Weybridge Business Park, Addlestone, KT15 2UP

Planning Application for 3 Industrial Units

LPA Ref: RU/22/0776

Objection on Transport and Highway Grounds

Figure 1 – Typical Traffic Congestion AM (Google)

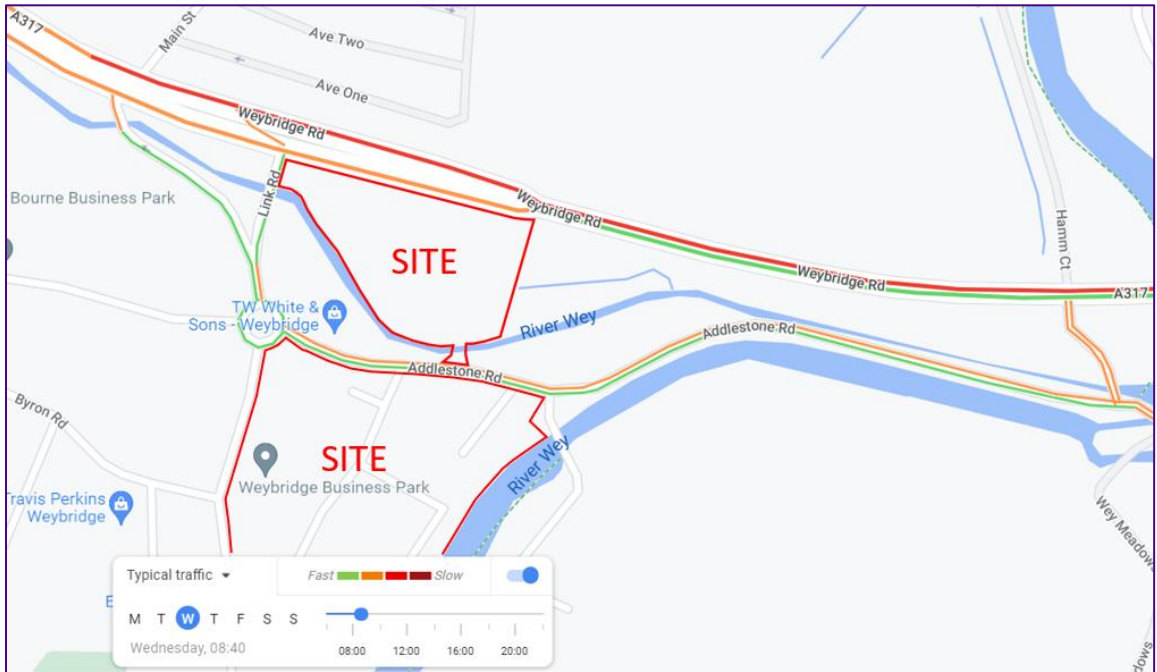
2.2.3 The congestion problems on Weybridge Road result in traffic being displaced onto Addlestone Road, leading to further congestion on this route. This (and the congestion on the A317) is illustrated in the Google traffic information in Figures 1 and 2 below:

- 2.2.4 The applicants' TA fails to acknowledge or quantify these problems, or include any analysis of the impacts from traffic generated by the development. The potential traffic impacts of the development are considered further in section 2.4.

Figure 3 – Accident Data

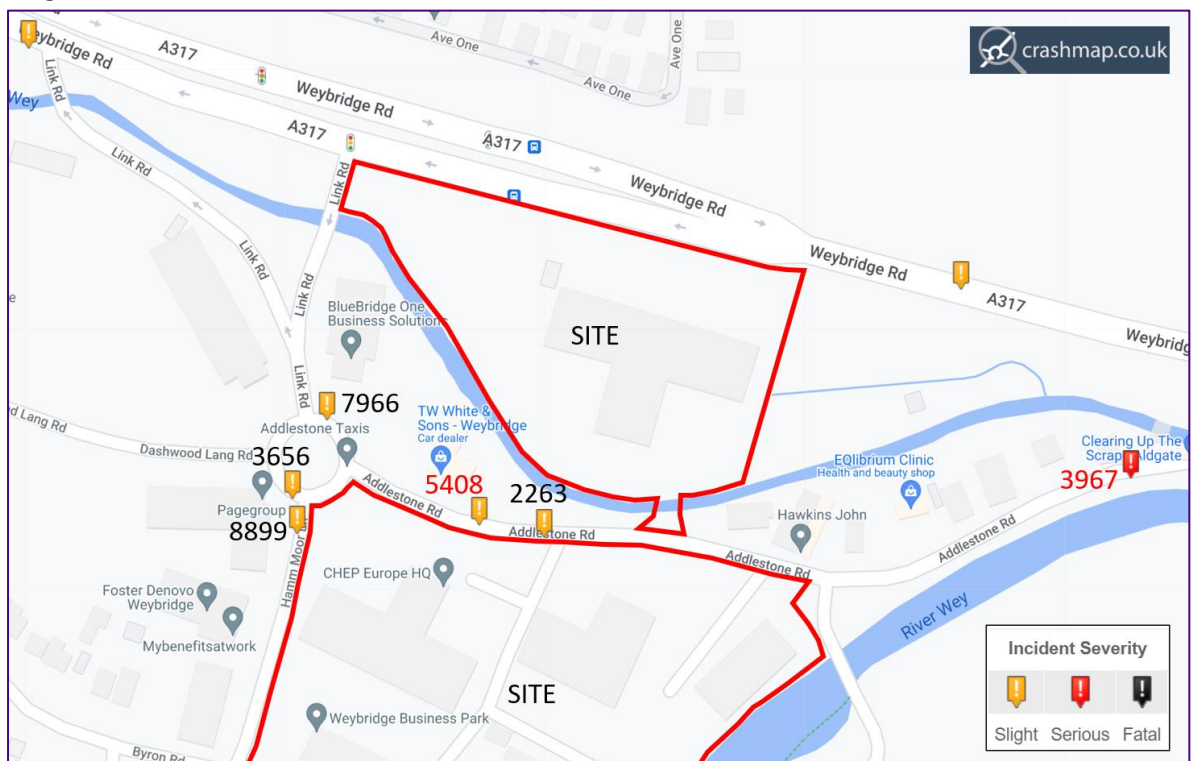
- 2.2.6 With regard to accident statistics, the mode TA provides details of Personal Injury Collisions (PIC) from the Crashmap UK database and shows 4 accidents in the vicinity of the site during the period from 2016 to 2021. However, the information presented is incomplete as two further accidents have occurred – identified with reference numbers shown in red font in Figure 3.

- 2.2.7 The two additional accidents include one categorised as 'slight' on Addlestone Road, close to the southern site access (Ref No 5408) which occurred on Tuesday 19 January 2021 at 12.27pm. Unfortunately, the Crashmap database currently only shows 'Provisional Data' for this accident and details of vehicle and casualty information are unavailable. A further, serious, accident took place on Addlestone Road approximately 150m east of the site (Ref No 3967) on Wednesday 24 April 2019 at 7.35am, when a van collided with a pedal cyclist resulting in serious injury to the rider.

Figure 4 – Proposed Site Layout

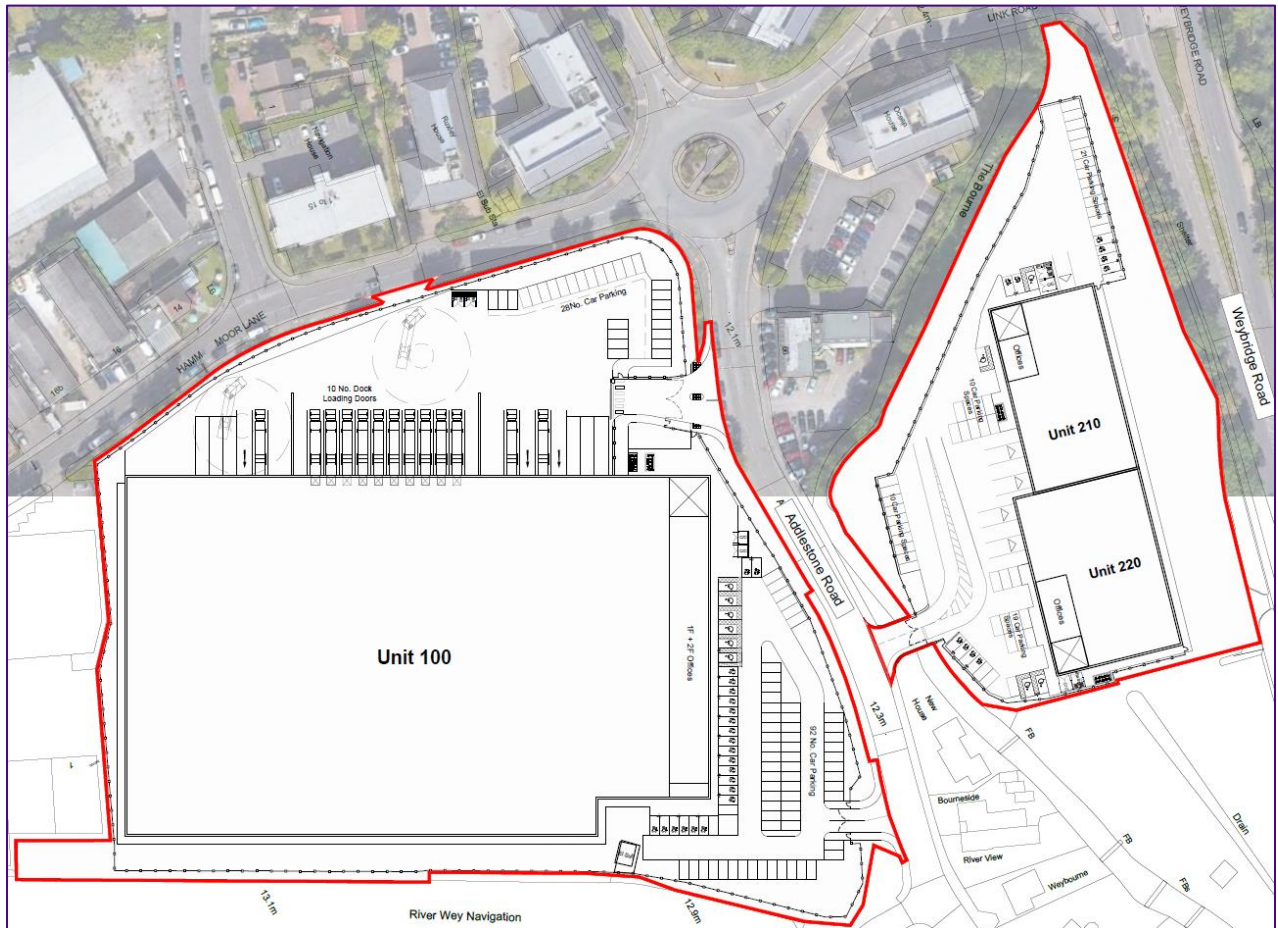
- 2.4.3 The proposed development is speculative, with no end-users identified at this stage. However, Unit 100 is clearly identifiable as a large scale storage and distribution facility, consistent with the demand set out in the applicants' Market Assessment report. This unit constitutes 83% of the total development floorspace.

- 2.4.4 The vehicle tracking drawings for this Unit (in Appendix D of the mode TA) indicate its intended use by 16.5m long articulated HGVs. The provision of 10 dock loading doors and parking/queuing capacity for an additional 12 articulated vehicles indicates the potential for an intensive B8 land use for this Unit.

- 2.4.5 Units 210 and 220 have been designed to accommodate 10m long rigid body HGVs. These two units comprise 8% and 9% of the total proposed development floorspace. The site layout and vehicle tracking drawings show five loading bays with parking/queuing capacity for a further two HGVs indicating that these buildings could also be used for storage or distribution, as well as other potential industrial or research and development uses.
